Bid Addendum No. 1 for:

MASON TRANSIT AUTHORITY – PEAR ORCHARD PARK AND RIDE PROJECT

All Bidders are required to make the following substitutions to the Bid Documents. Below is a description of the revisions made to the Contract Documents.

DRAWING No.: IL-1
SHEET No.: 14 OF 23

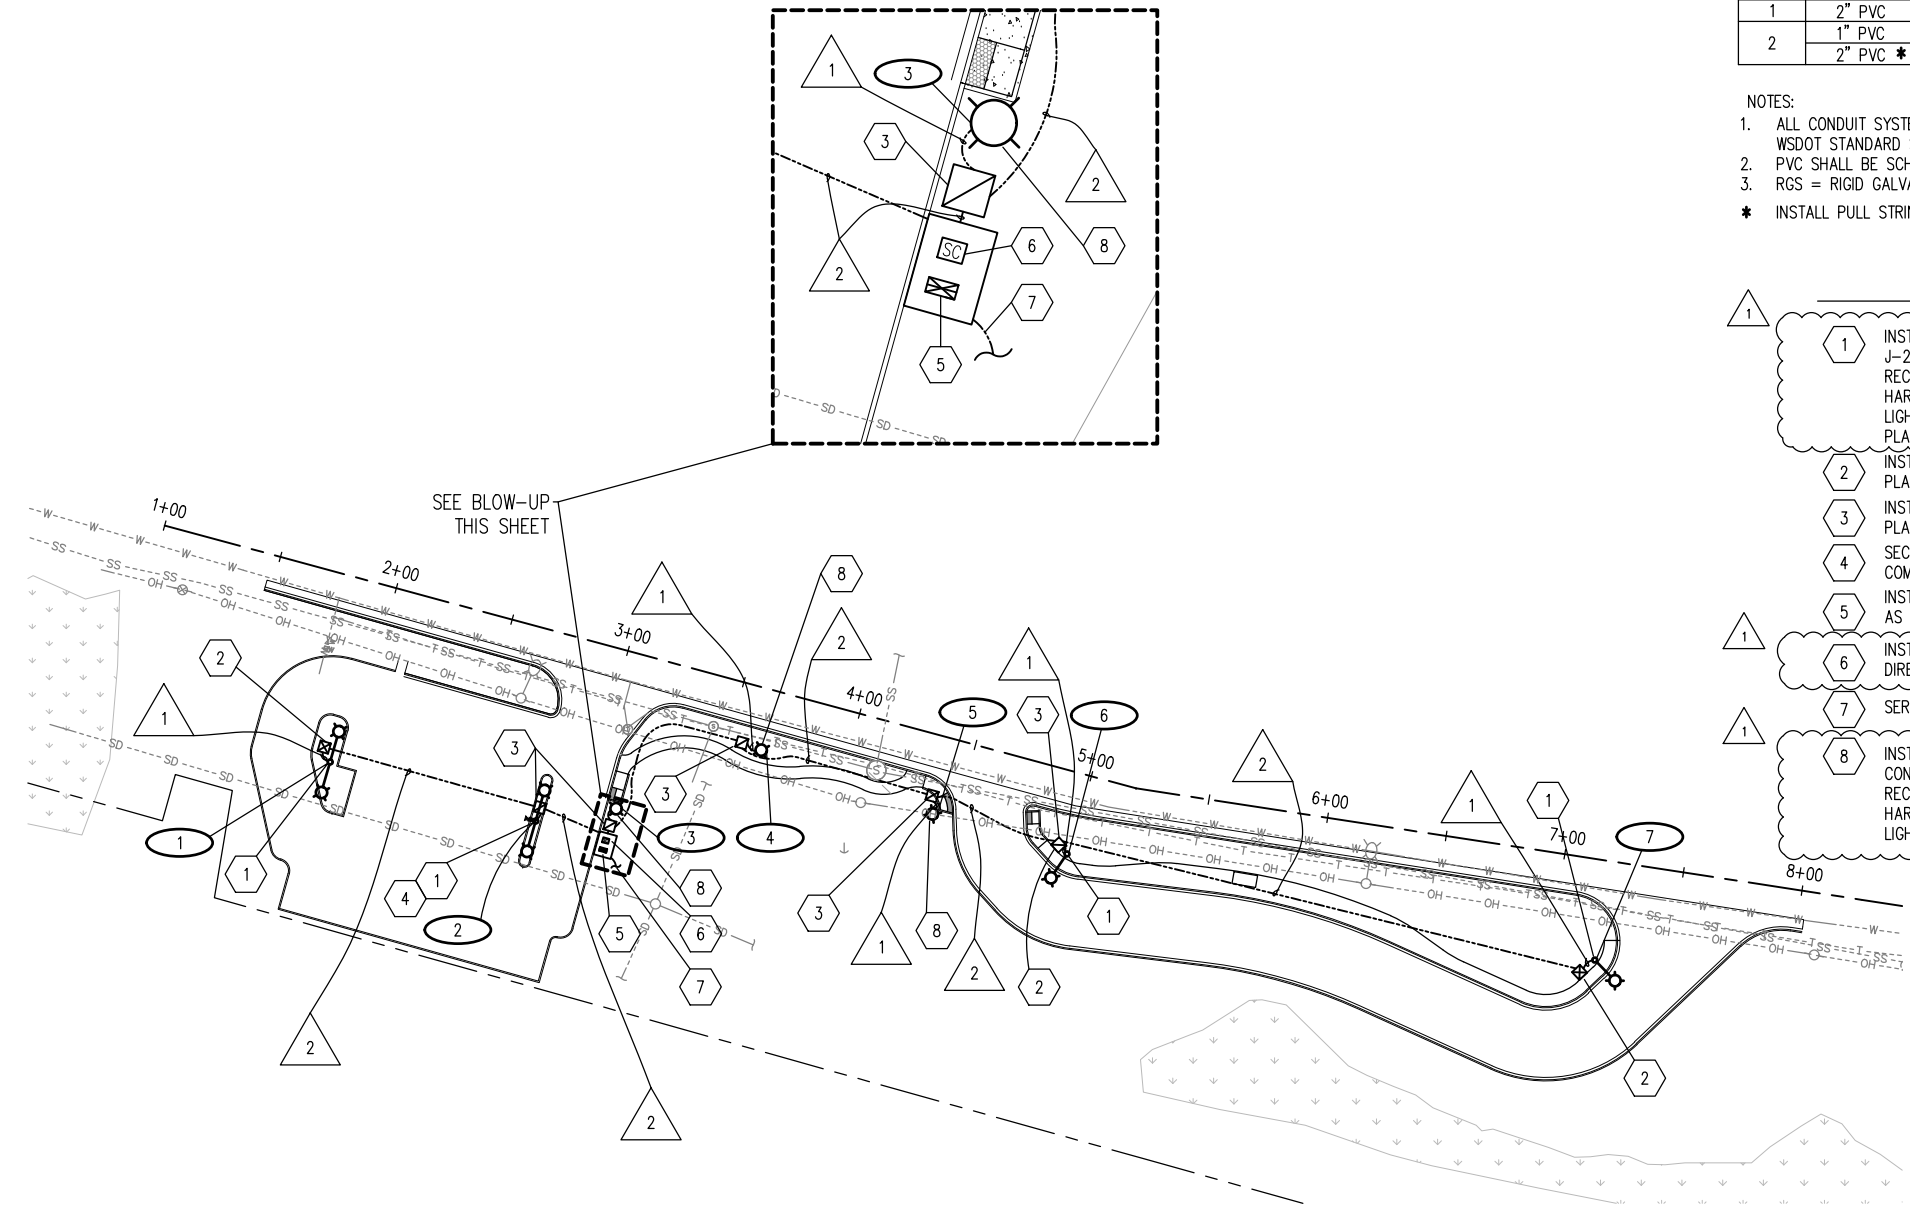
- Updated illumination construction notes.
- Updated lighting schedule.

DRAWING No.: LS-1

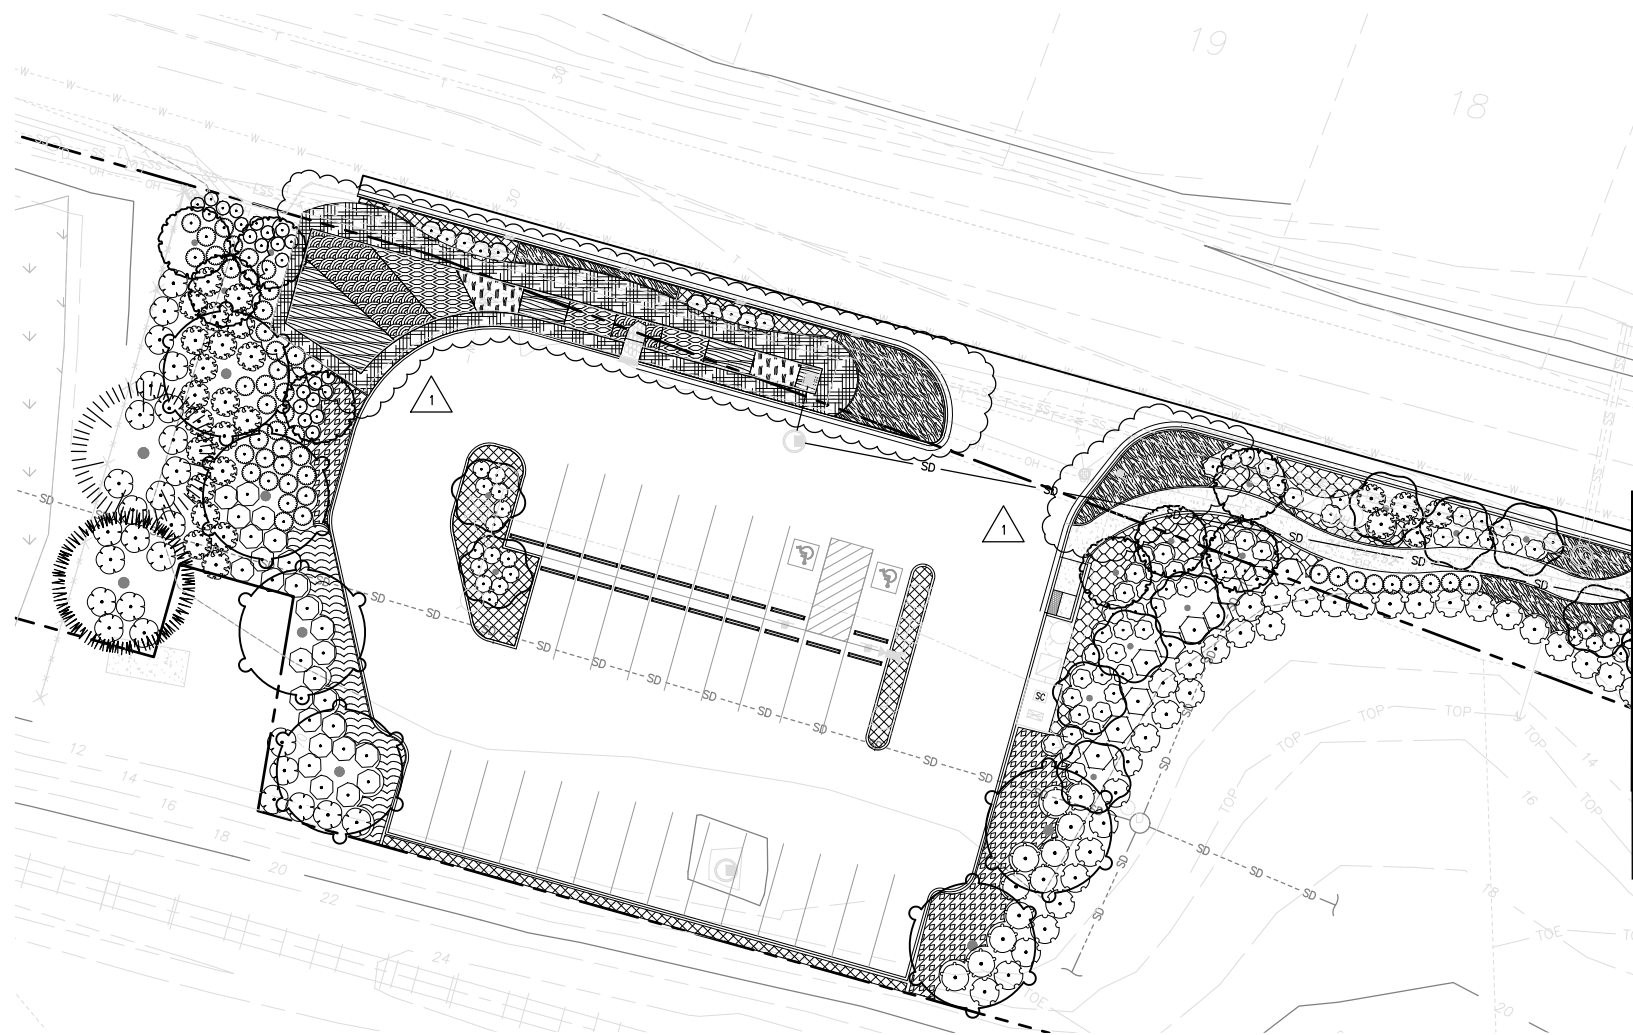
- Revised landscaping to match pond modifications.

DRAWING No.: LS-2

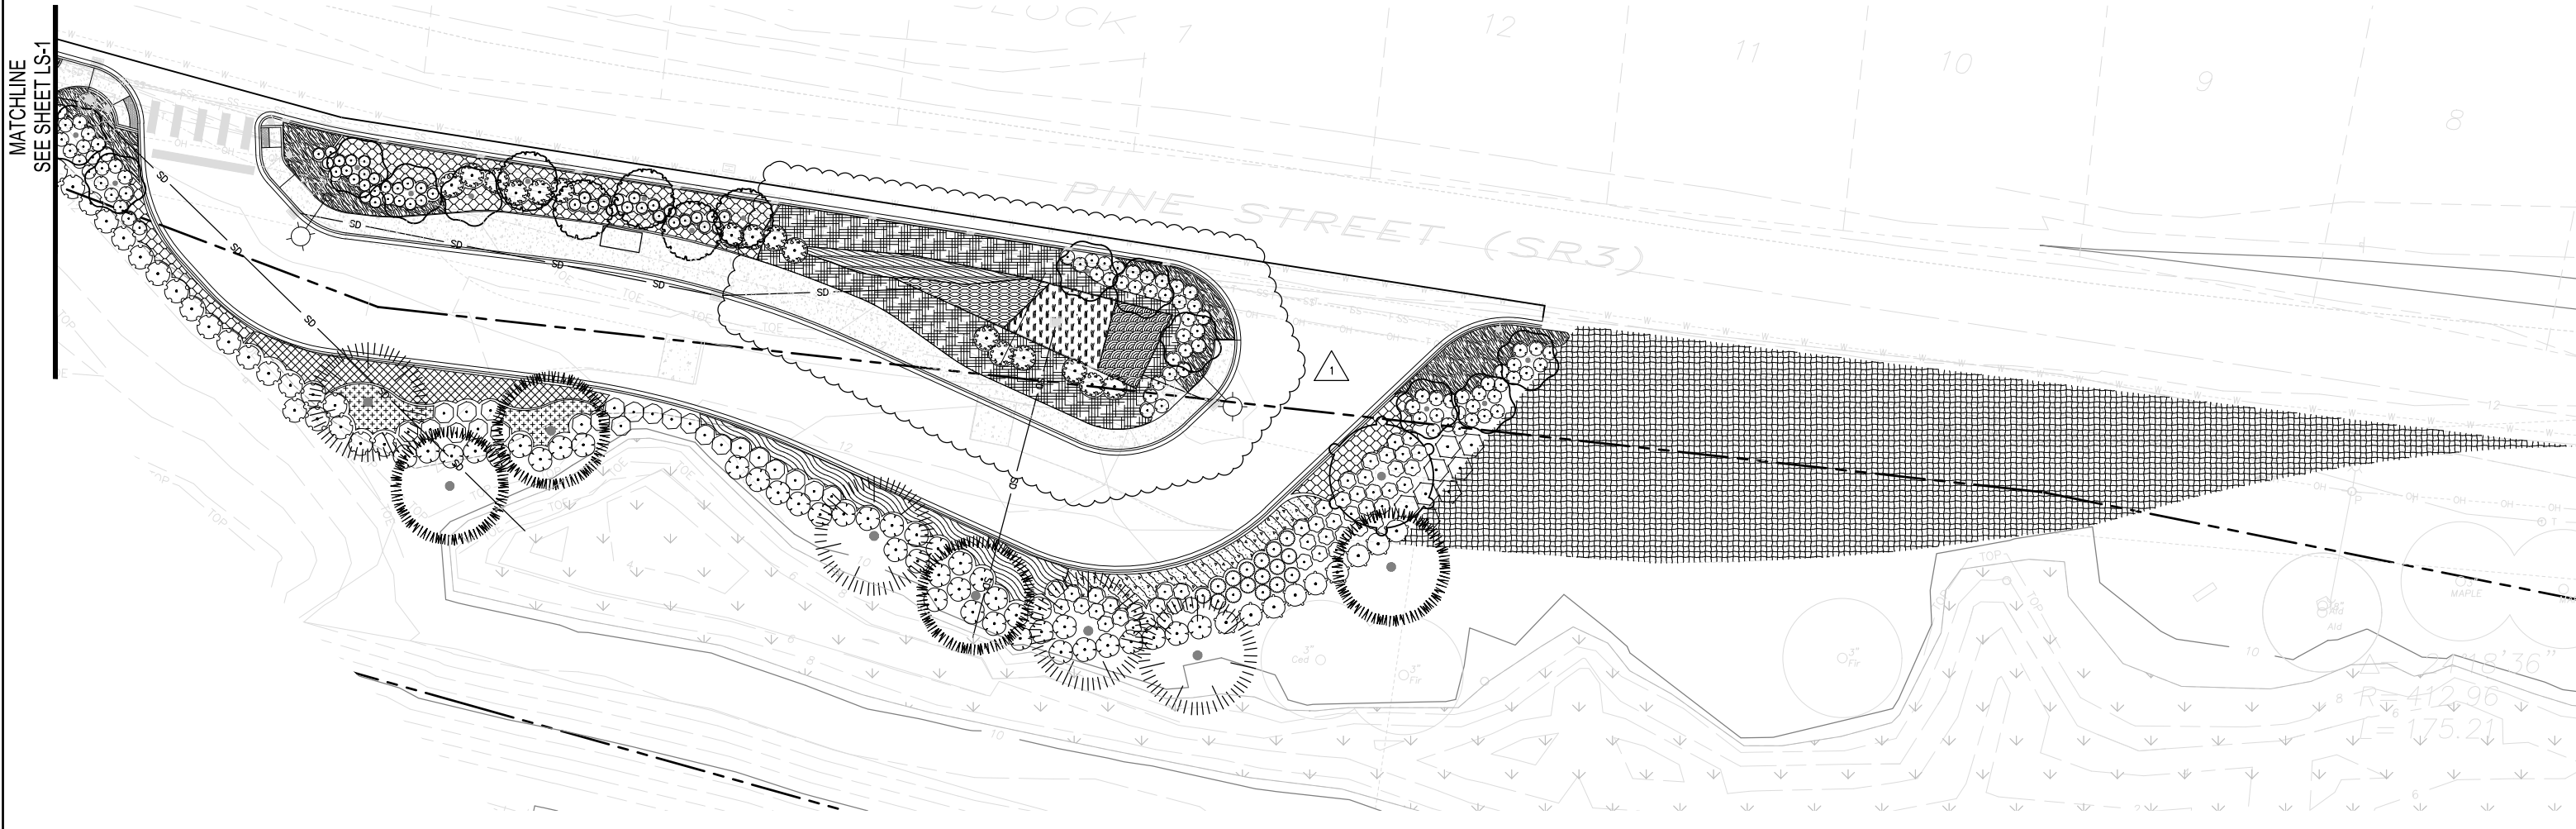
- Revised landscaping to match pond modifications.

DRAWING No.:
LS-4

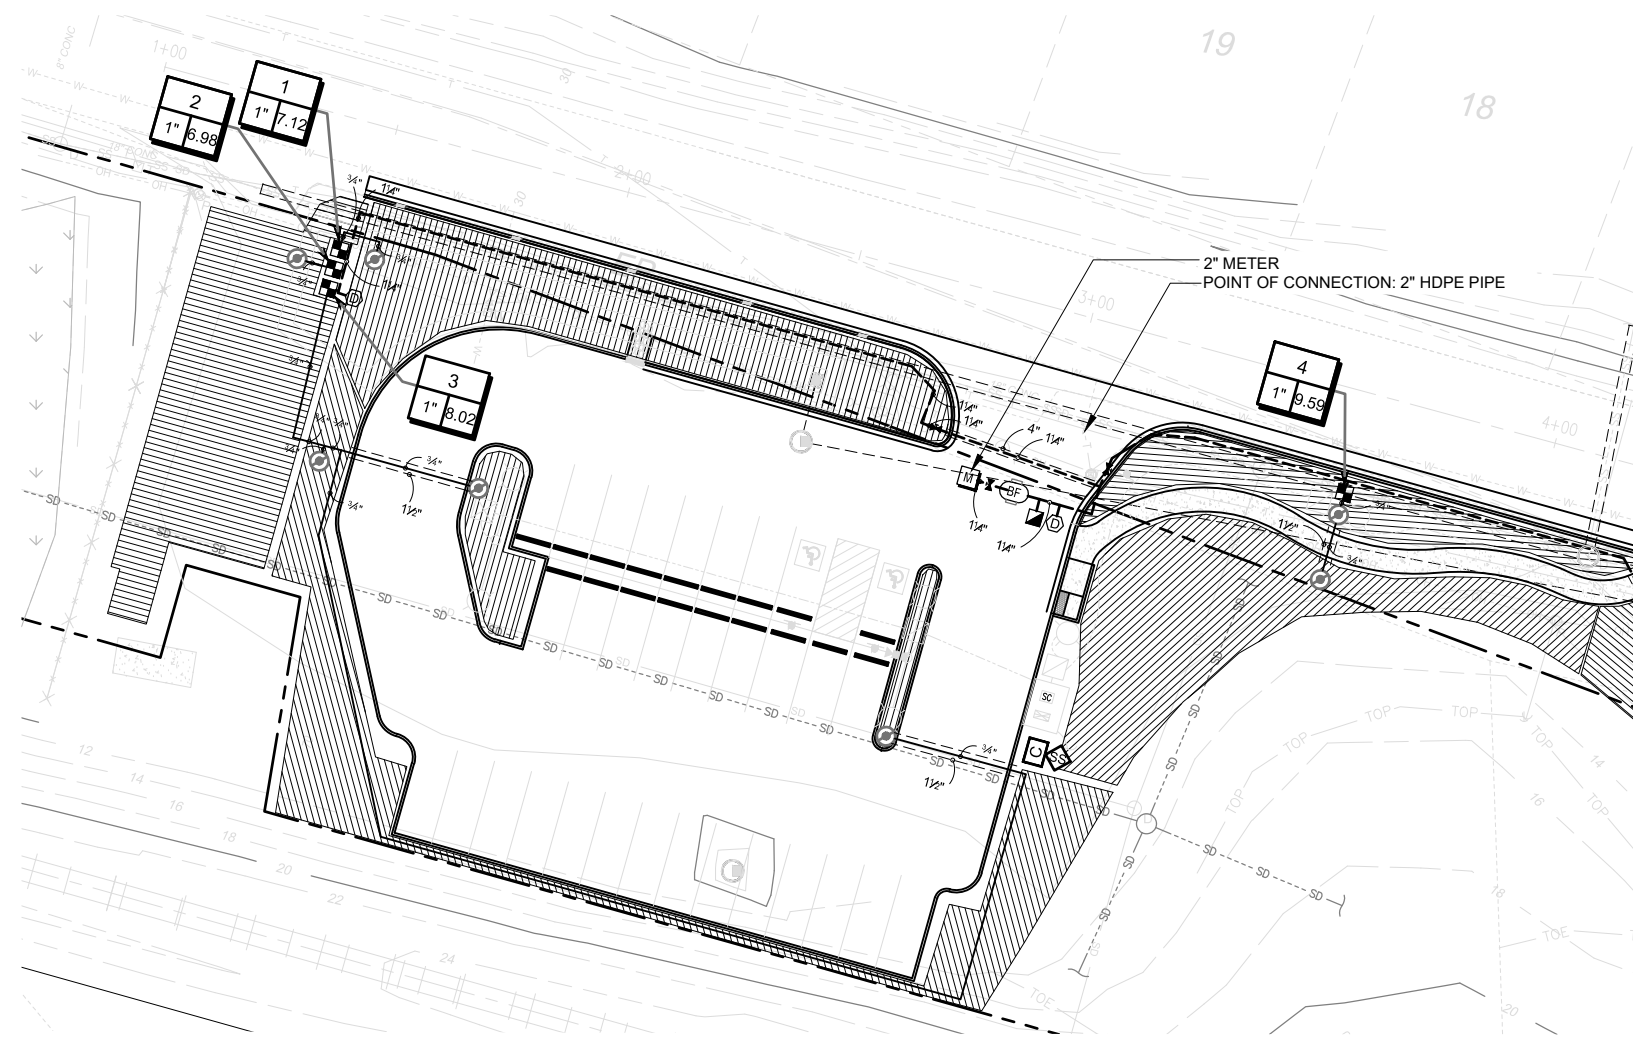
- Revised irrigation to match pond modifications.
